Subject: AP1000 Response to Request for Additional Information (SRP 3)

RAI-SRP3.7.1-SEB1-10 R2

Response to Request for Additional Information on SRP Section 3

RAI Response Number: RAI-SRP3.7.1-SEB1-10

## Response to Request For Additional Information (RAI)

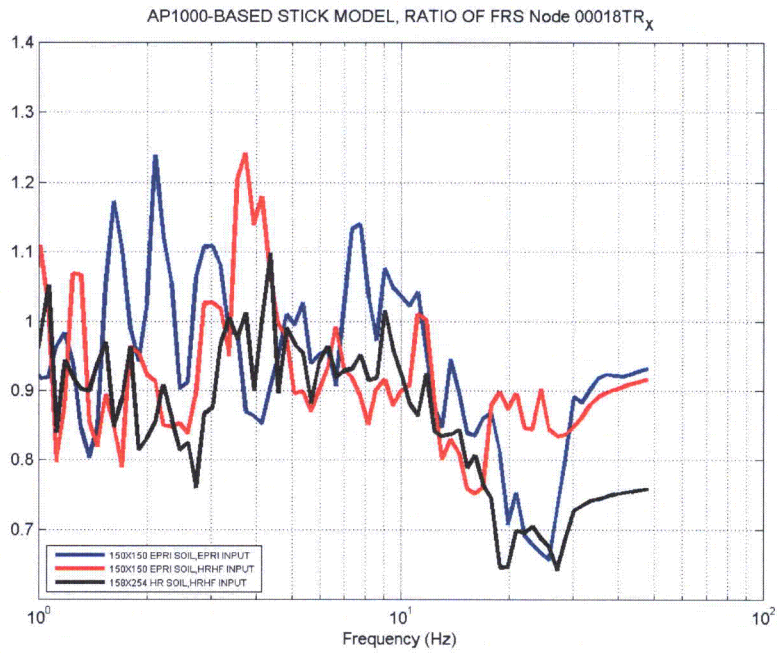
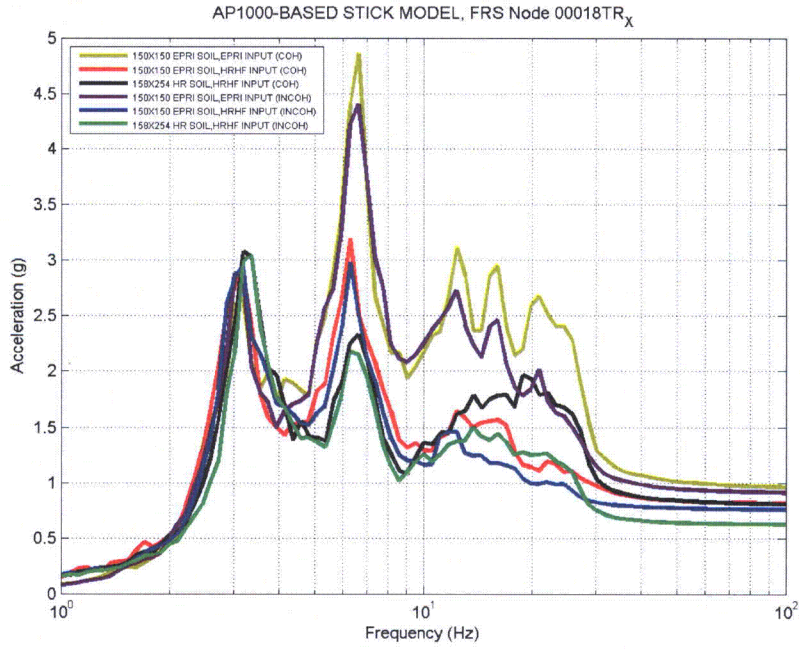
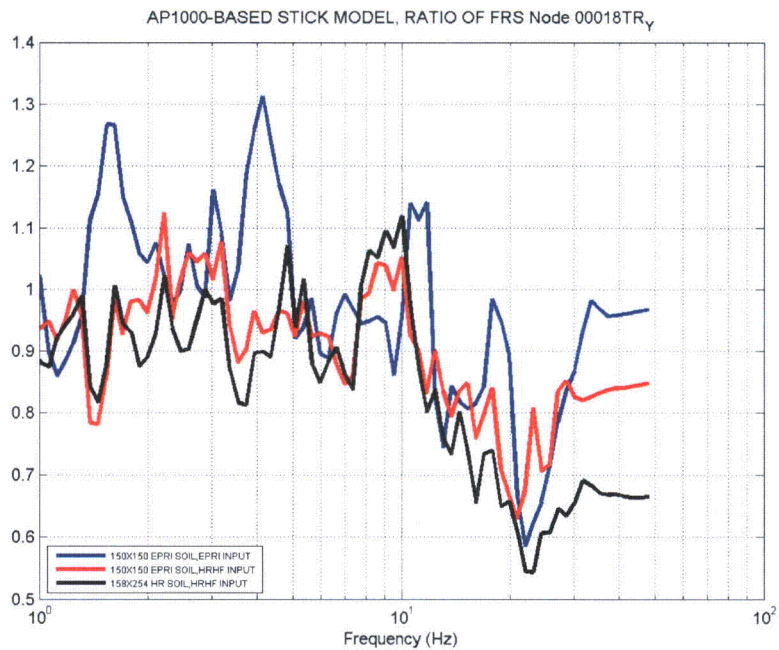
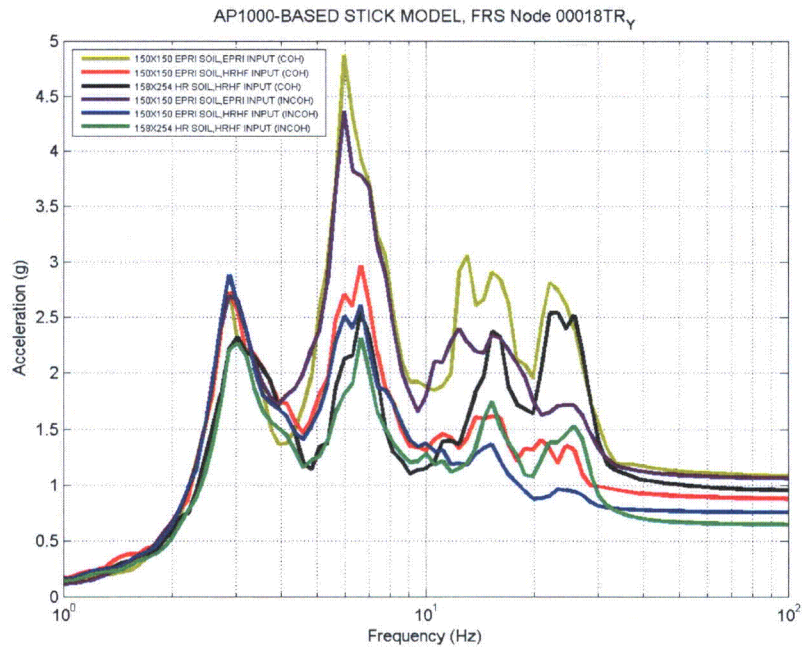
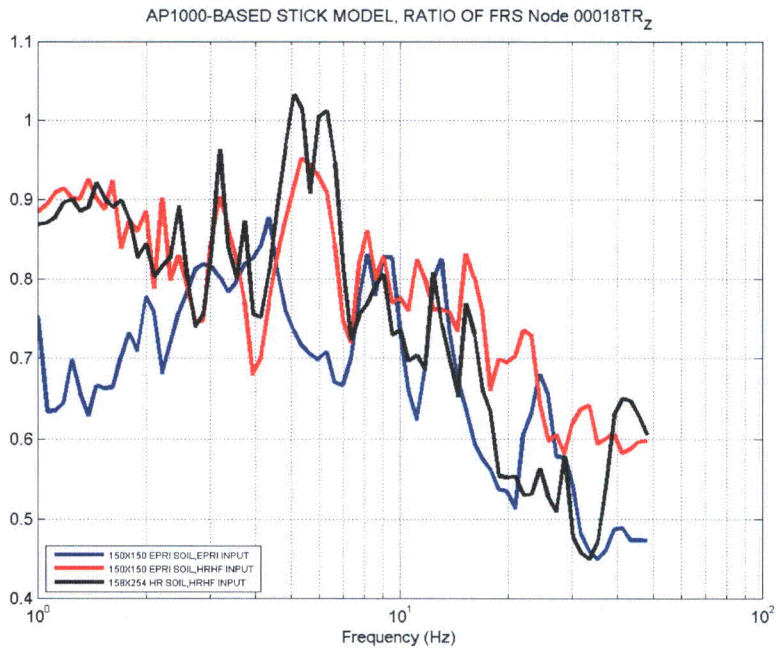
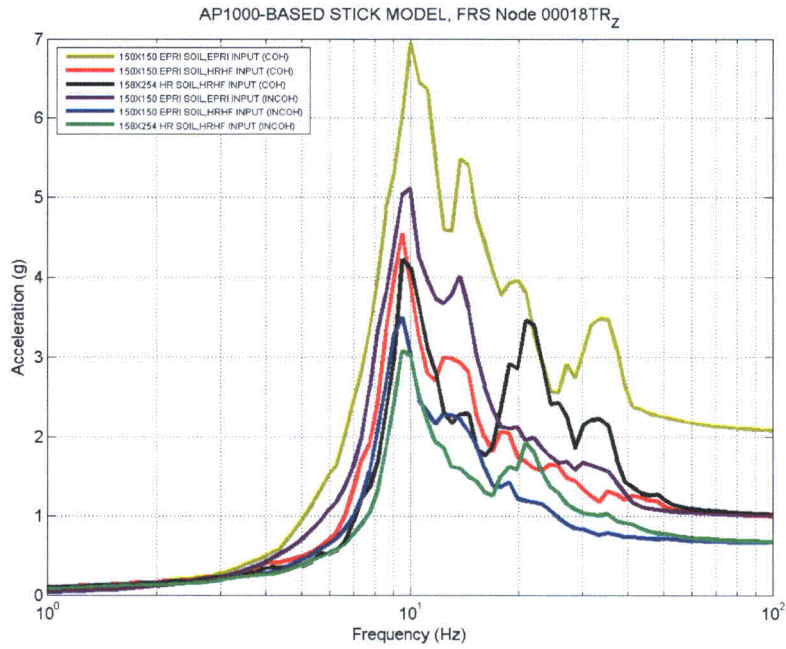
Perform additional calculations using EPRI model and rectangular foundation and AP1000 on hard rock foundation.

The 5% damping floor response spectra of four nodes and the reduction factors (Coh/Incoh) are shown in Figures RAI-SRP3.7.1-SEB1-10-22 to RAI-SRP3.7.1-SEB1-10-33. The Nuclear Island foundation results at elevation 60.5' (Node 1) show that the larger foundation will have larger reduction in response due to incoherency effects. The results for Top of Containment Internal Structure Mass Center at elevation 169' (Node 129), show reductions of the magnitude seen in the NI20 results. The top of the steel containment vessel and the top of the shield building also show similar results.
